# 917 Whann Avenue McLean, Virginia

Encroachment Exception Request #1996-WRPA-016-1  
Water Quality Impact Assessment #1996-WQ-005-2

September 7, 2022

# Proposed Reforestation

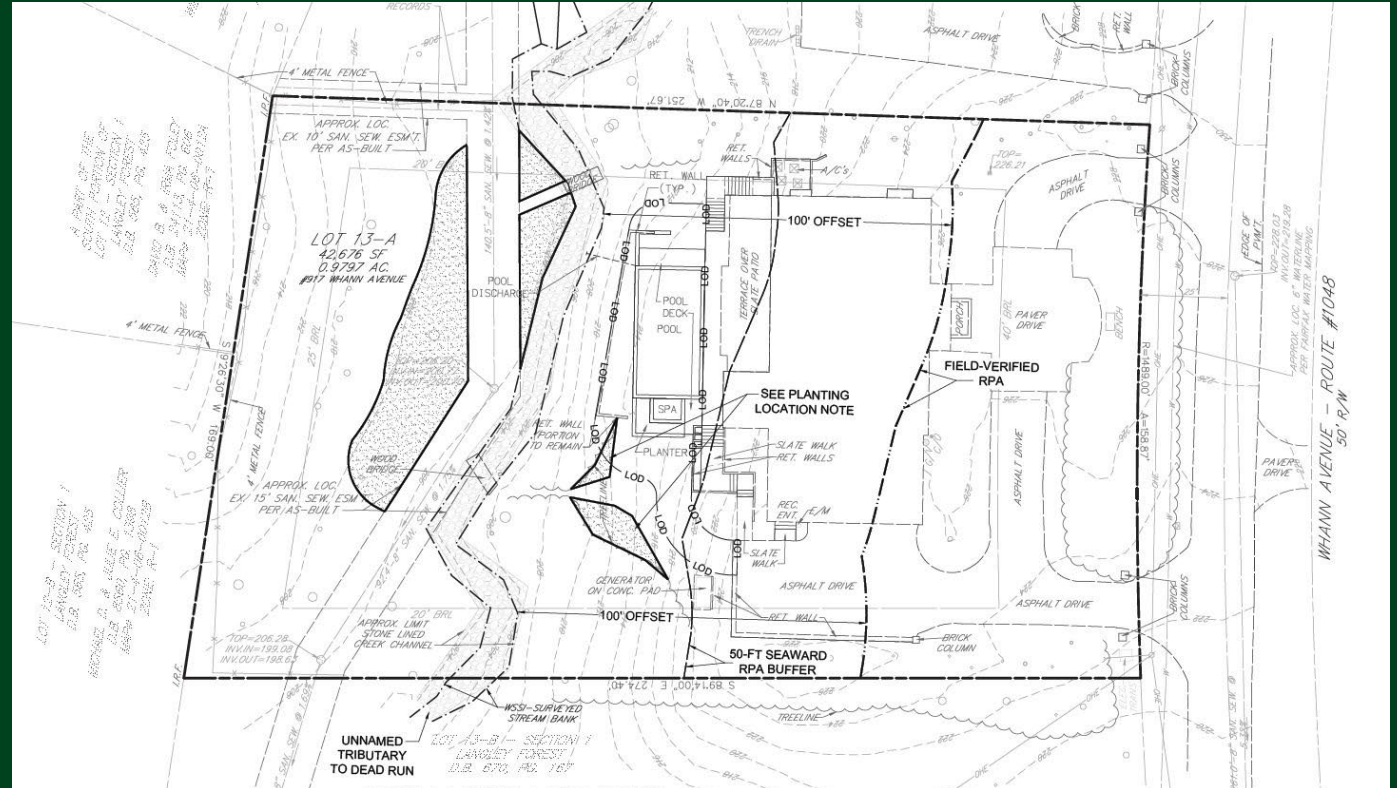
- Staff Desire Reforestation of areas on the East side of the stream
  - Staff interprets that proposed planting area was more vegetated in 2003
    - We respectfully disagree. Comparing Staff's Leaf-Off aerials from 2003 to 2011 shows instead significant growth of trees and canopy coverage

- Aerial photography is difficult to discern – however no violations for unauthorized clearing have been noted or issued for the property since RPA establishment

- The Applicant's ability to mitigate natural understory vegetation loss due to shading from the large canopy is hindered by the presence of the sewer easement

- The Applicant is open to discussing options for modification of the vegetation schedule (reducing trees in favor of more shrubs, and/or adding riparian seed throughout the sanitary easement) – but a reduction in planting credit for the proposed area based on low-resolution leaf-off aerial imagery is not supported
